# Access Compliance Report

## Public Rights-of-Way

### (Curb Ramps)

Intersection ID: 27323	Main Street: MEADOW_RUN_LN	Cross Street: THORNHILL_CLUB_DR	Location: SW
ADA ID: 972C5523B26D	Ramp Type: Perp	Initial Pass/Fail: Fail	Overall Compliance: No
		Severity Score: 12.5

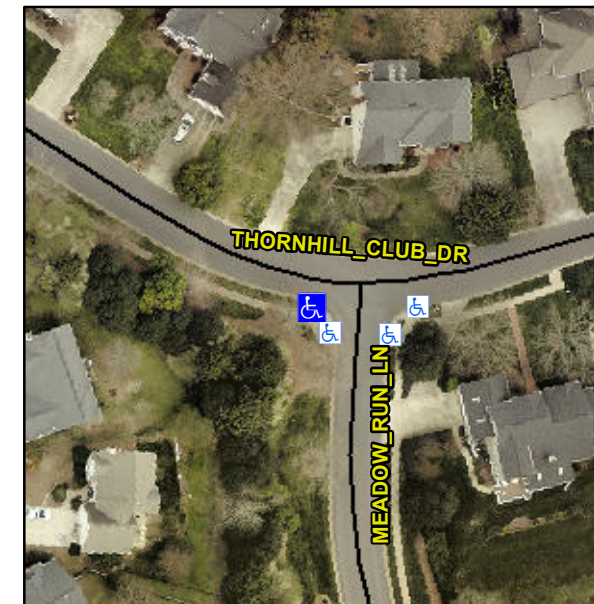
**Not Found, R304.2.2**

Compliance	Description	Data	Compliance	Description	Data
N/A	Ramp Length (in)	109.0	No	Ramp Slope (%)	10.0
Yes	Ramp Width (in)	48.0	Yes	Ramp XSlope (%)	0.8
N/A	Flare Type LT	N/A	N/A	Flare Type RT	N/A
N/A	Flare Slope LT (%)	N/A	N/A	Flare Slope RT (%)	N/A
N/A	Flare Traversable LT?	N/A	N/A	Flare Traversable RT?	N/A
N/A	Landing Length (in)	N/A	N/A	DWS Provided?	N/A
N/A	Landing Width (in)	N/A	N/A	DWS Contrast?	N/A
N/A	Landing Slope (%)	N/A	N/A	DWS Length (in)	N/A
N/A	Landing X Slope (%)	N/A	N/A	DWS Full Width?	N/A
N/A	Landing Curb? (Y/N)	N/A	N/A	DWS Offset (in)	N/A
N/A	Shared Landing?	N/A			
N/A	Gutter Ponding?	N/A	N/A	Gutter Slope (%)	N/A
N/A	Gutter Lip Ht (in)	N/A	N/A	Gutter X Slope (%)	N/A
N/A	Painted X Walk1?	No	N/A	Painted X Walk2?	N/A
	X Walk 1 Direction	To N		X Walk 2 Direction	N/A
N/A	X Walk 1 Width (in)	N/A	N/A	X Walk 2 Width (in)	N/A
	X Walk 1 Slope (%)	3.2		X Walk 2 Slope (%)	N/A
	X Walk 1 X Slope (%)	0.9		X Walk 2 X Slope (%)	N/A

**Remove & Replace Entire Ramp.**
